Agenda for 82nd PCC Meeting

EASTERN REGIONAL POWER COMMITTEE

AGENDA FOR 82ND PROTECTION SUB-COMMITTEE MEETING TO BE HELD AT ERPC, KOLKATA ON 19.08.2019 (MONDAY) AT 11:00 HOURS

DR recorded at Tashiding end of 220 kV Tashiding New Melli S/C at 14:31:59.472 hrs (while charging the line on next day)

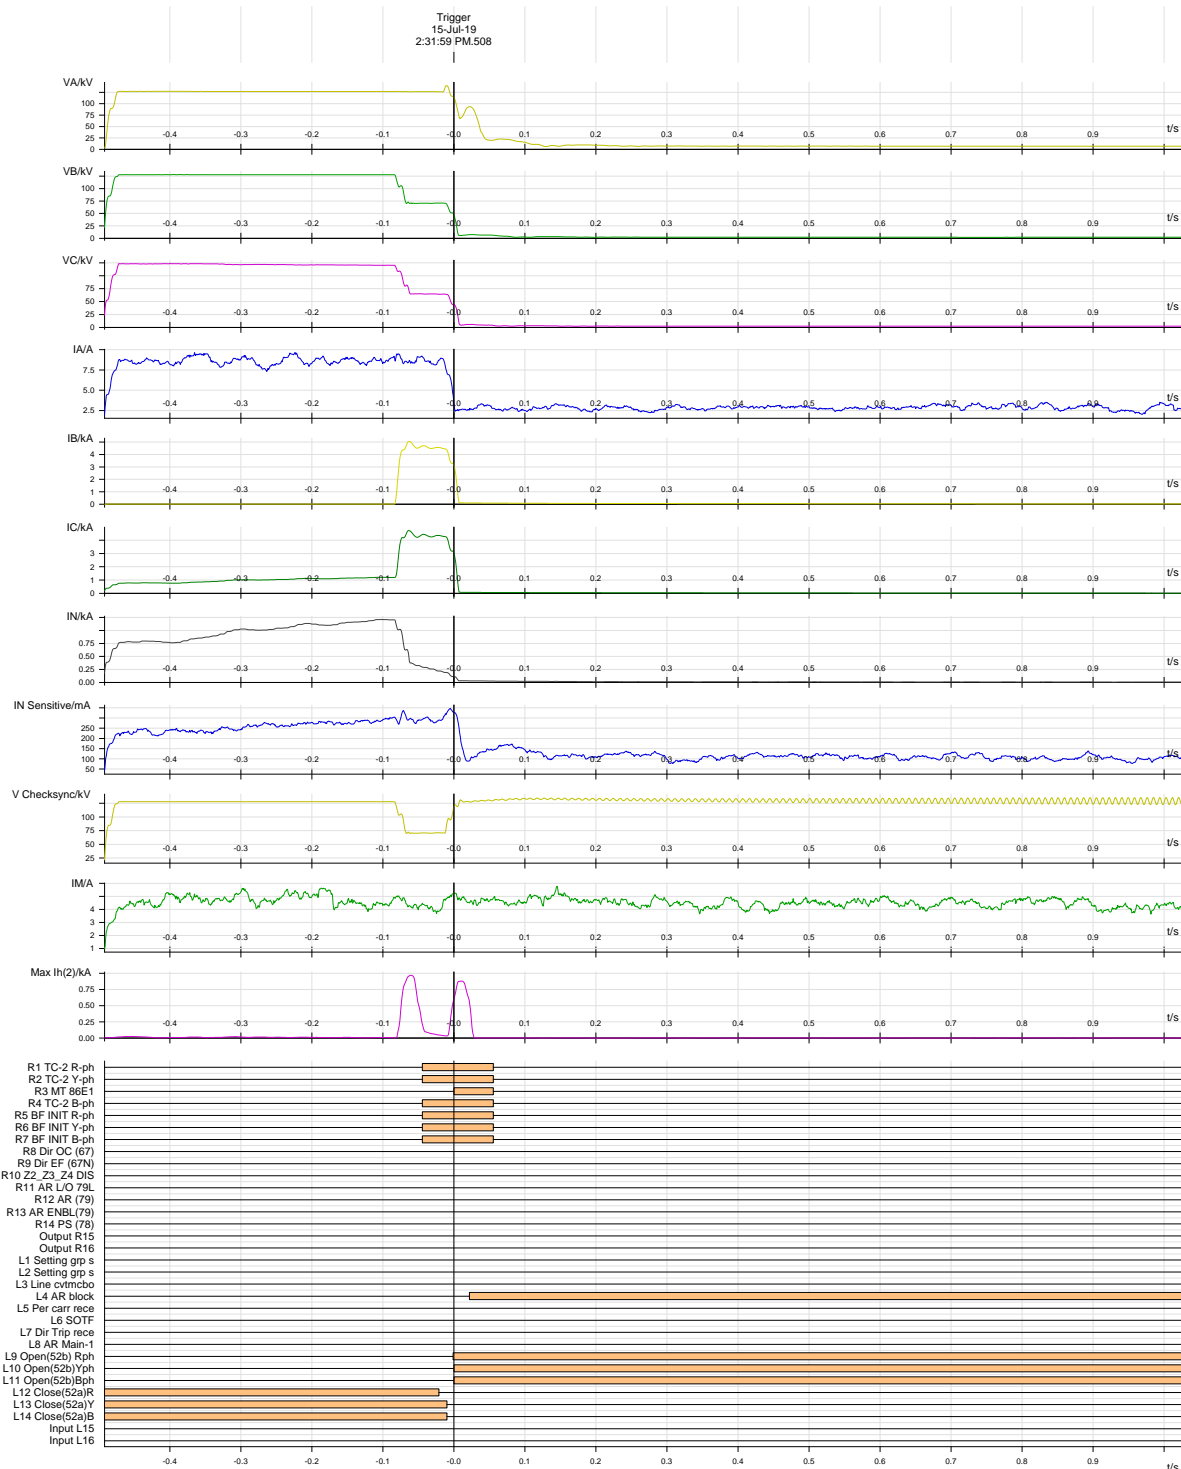
Y-B, F/C 3.53kA in Y phase & 3.65 kA in B phase. Digital channels of DR outputs may be configured (Z-II, Z-III & Z-IV pick ups was not available) as per recommendations given in 79th PCC meeting.

Annexure II: DR for 220 kV Siliguri – Dalkhola – II at Siliguri at 03:57 hrs on 22-07-19

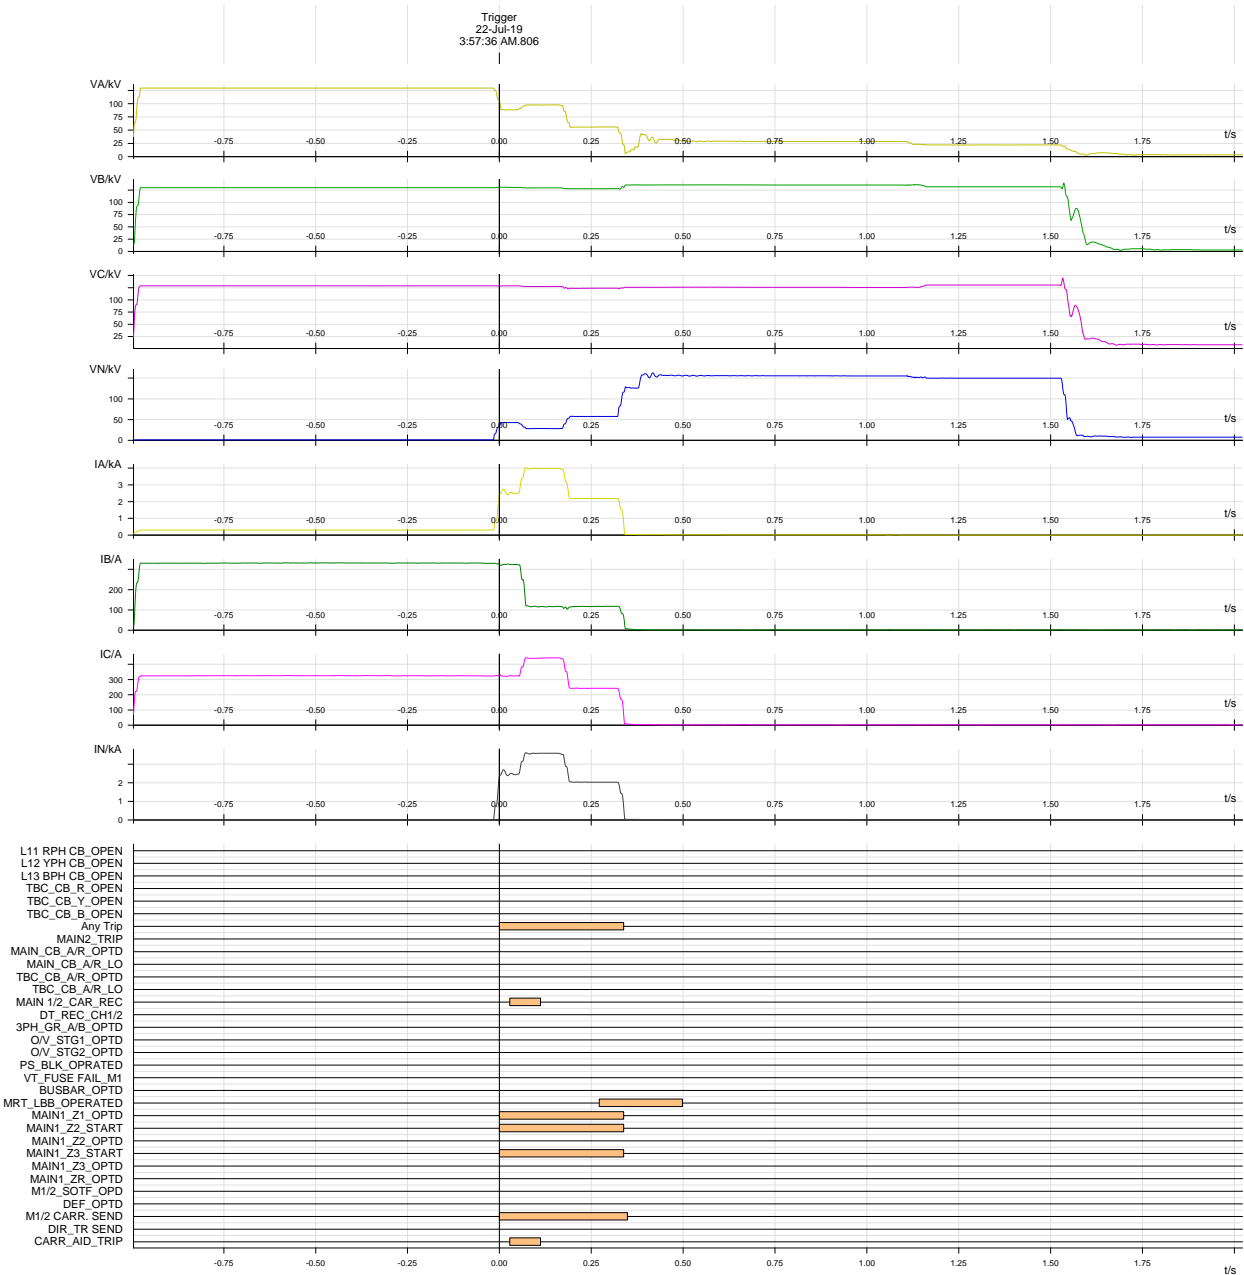
- Reason for tripping of LBB operation at Siliguri S/S may be explained by POWERGRID ERTS-II. DR is not time-synchronized at Siliguri S/S.
- Y-N fault occurred at 220 kV Siliguri – Dalkhola D/C at 03:26 hrs on 21-07-19 (Almost same time on previous day). Successful A/R occurred at both ends for circuit I. But A/R was unsuccessful for circuit II at Dalkhola end due to tripping of all three poles in pole discrepancy (DR attached in Annexure III). POWERGRID ERTS-II may explain.

Remarks: R-N, Z-I, LBB operated; Digital signal for breaker operation is not recorded in DR.

Annexure III: DR for 220 kV Siliguri – Dalkhola – II at Siliguri at 03:28 hrs on 21-07-19

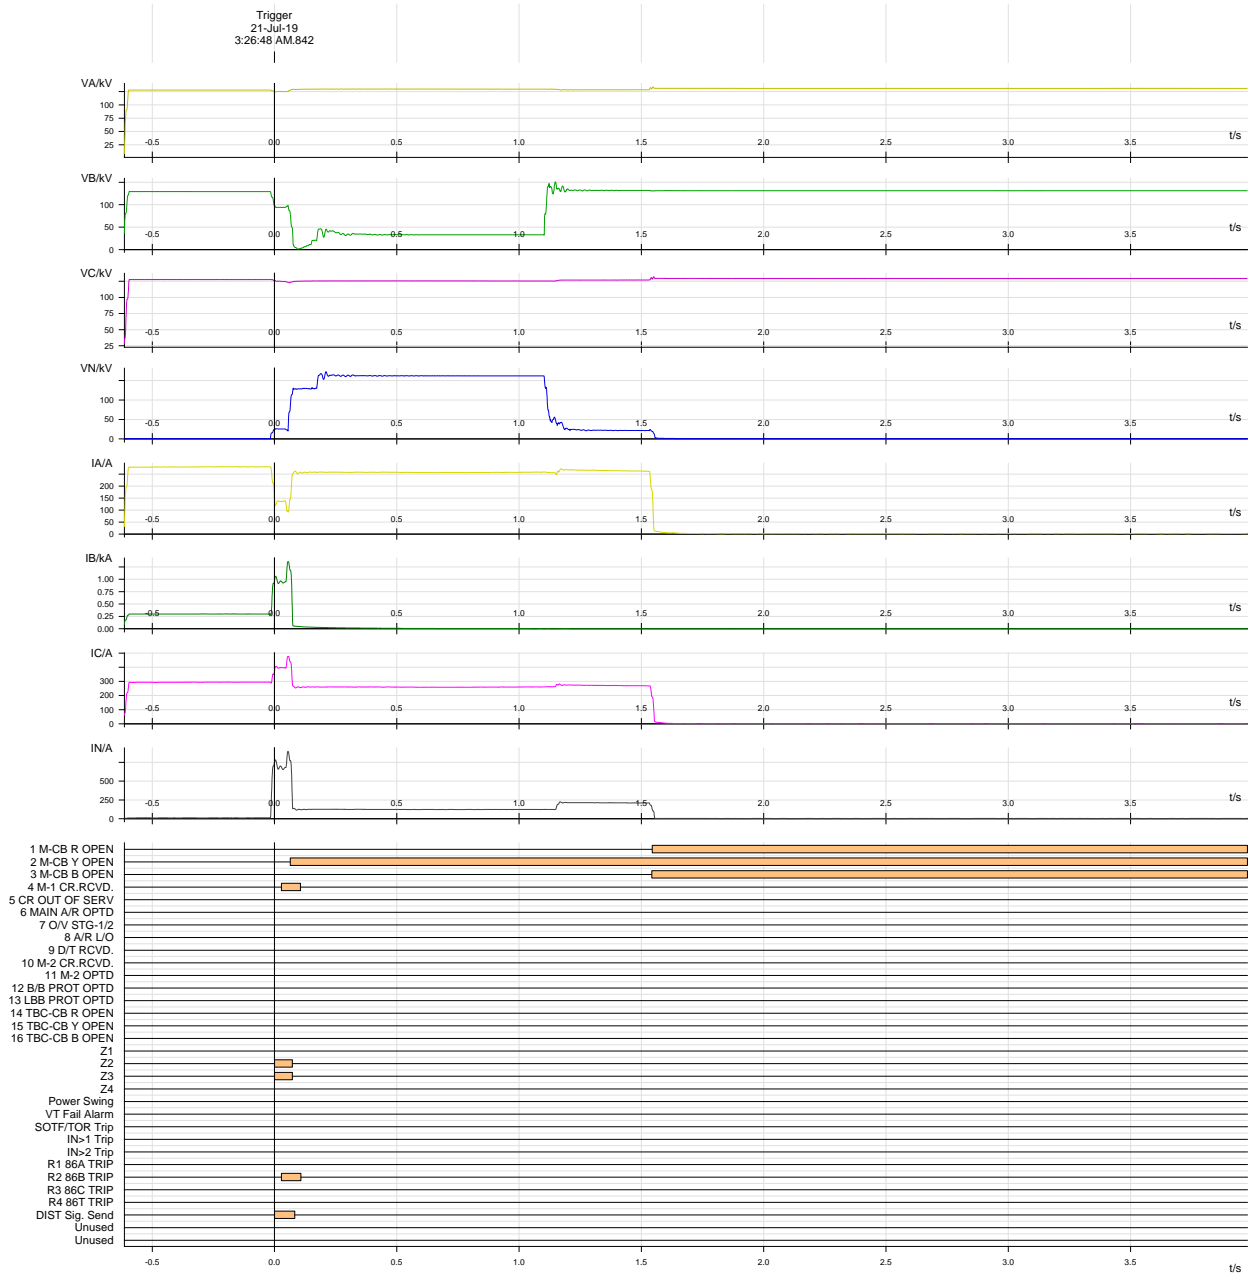
Remarks: Y-N, Z-II (carrier received), Y pole remained open for more than 1.5 seconds. Three pole tripped after that.

DR recorded at Barh for 400 kV Kahalgaon – I feeder at 14:52:46 hrs on 27th July 2019

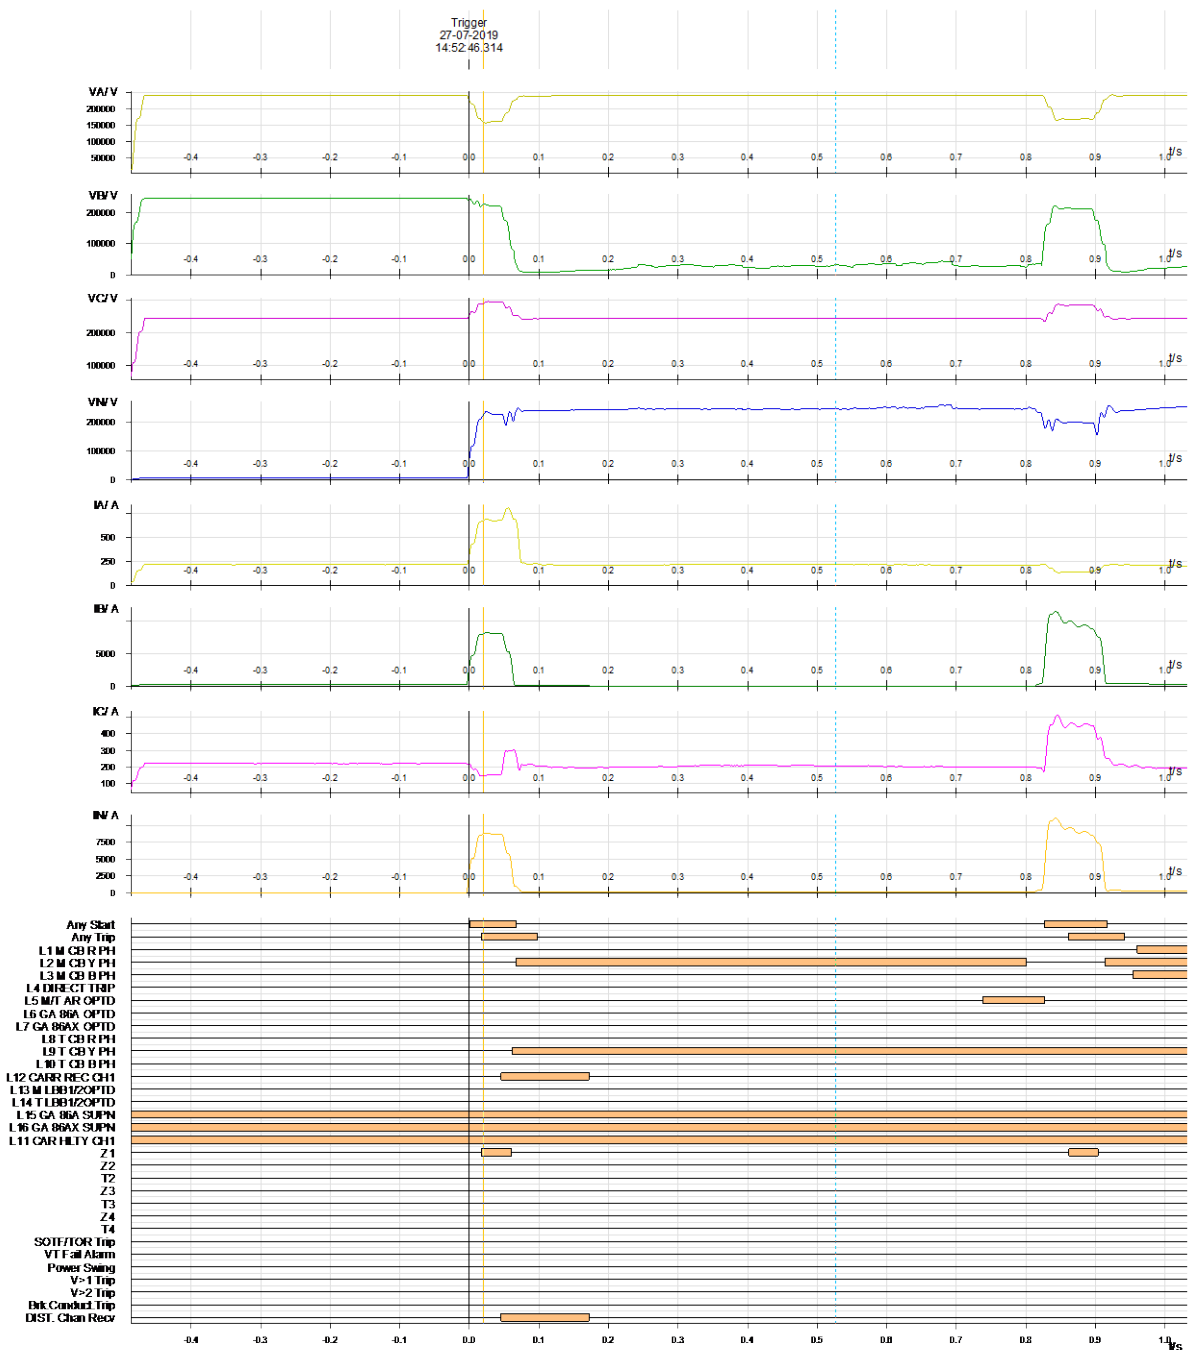
Observation: Unsuccessful A/R attempt was taken at Barh end for Y phase fault. It has been observed, tie breaker at R and B phase did not open after the unsuccessful A/R attempt of Y phase main breaker. It resulted current to be flown in healthy phases even after unsuccessful A/R attempt.

DR recorded at Barh for 400 kV Kahalgaon – I feeder at 14:52:47 hrson 27th July 2019

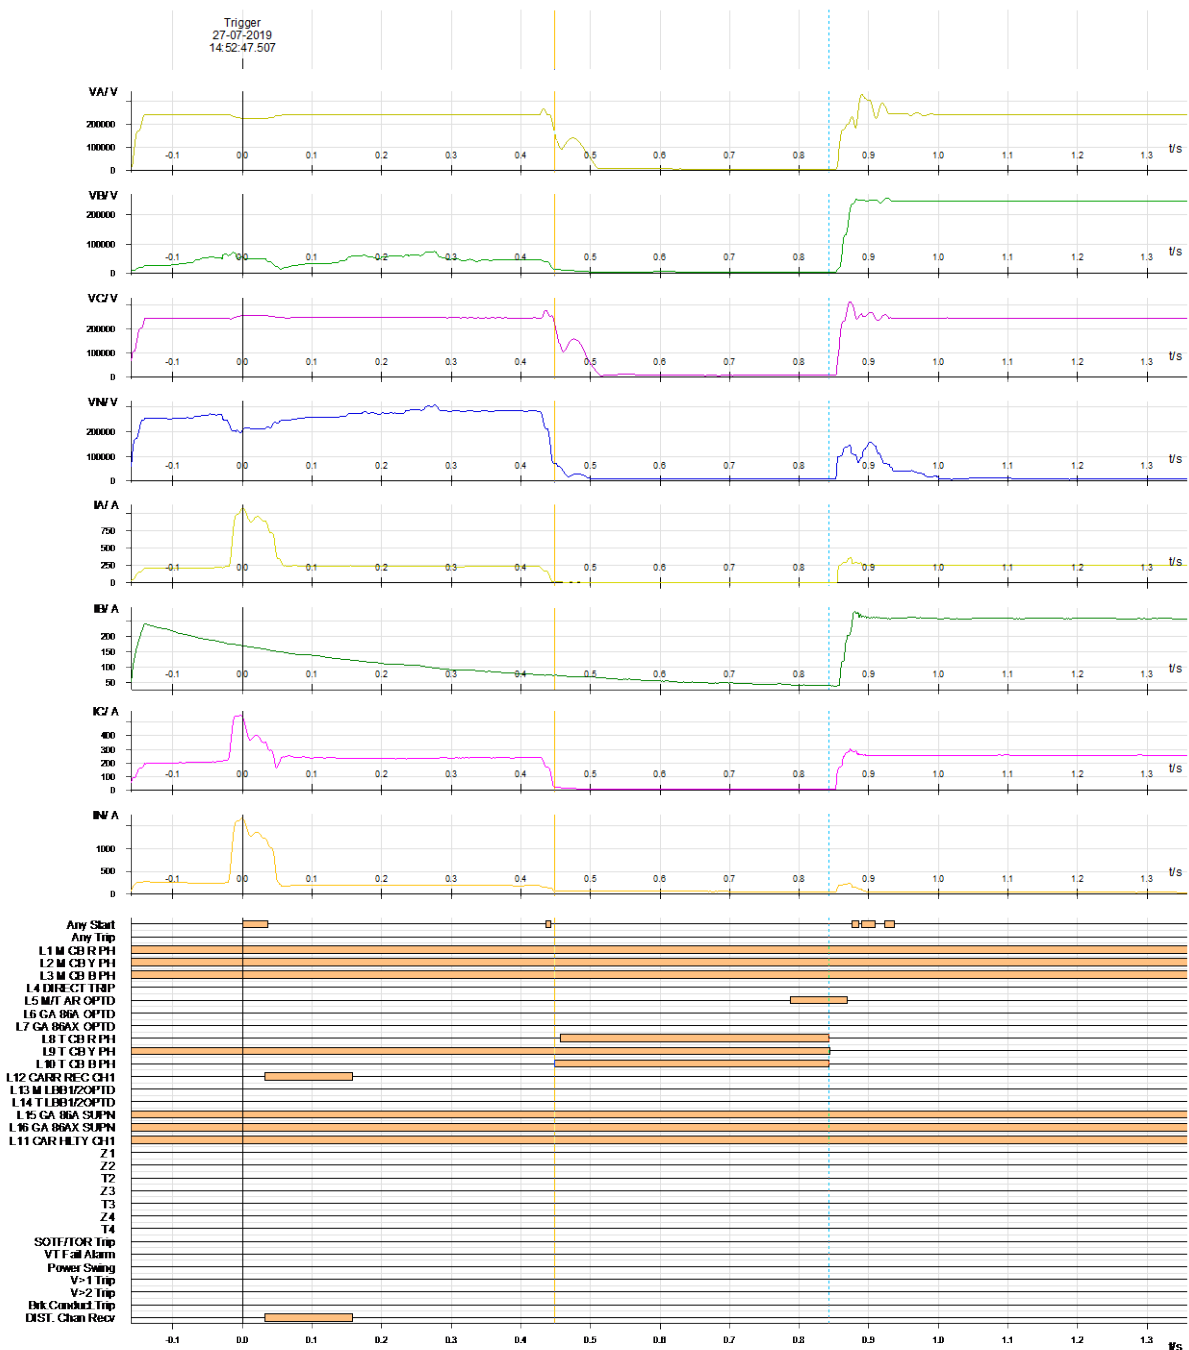
Observation: Approximately 400 ms after opening of tie breaker in R & B phase (Y phase tie breaker was in already open condition), all three-phase tie breaker closed again. This time fault was not observed in Y phase. Current in all three phases was low as line was opened from remote end.

Annexure III: DR recorded at Biharshariff end for 400 kV Sasaram – Biharshariff - I

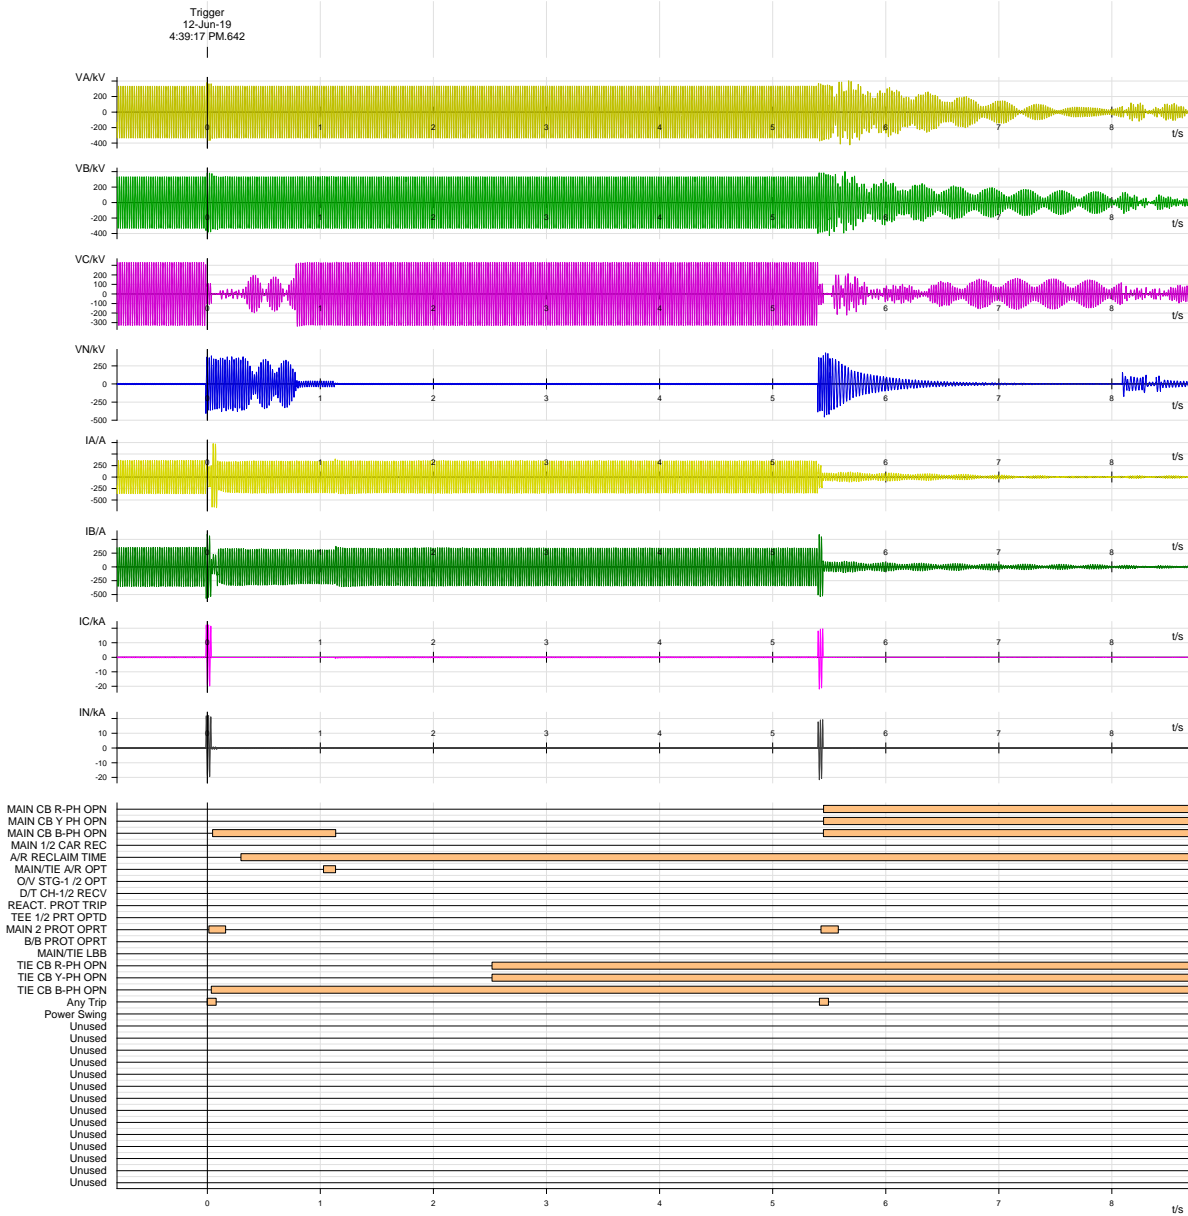
Successful A/R from Biharshariff end due to B-N fault. Tie breaker did not close. Hence other two breakers opened in pole discrepancy after 2.5 seconds. Three poles of main breaker tripped after 5.4 seconds due to another B-N fault in reclaim time.

All required digital channels are not available. DR channels may be configured as per discussion in 79th PCC meeting.
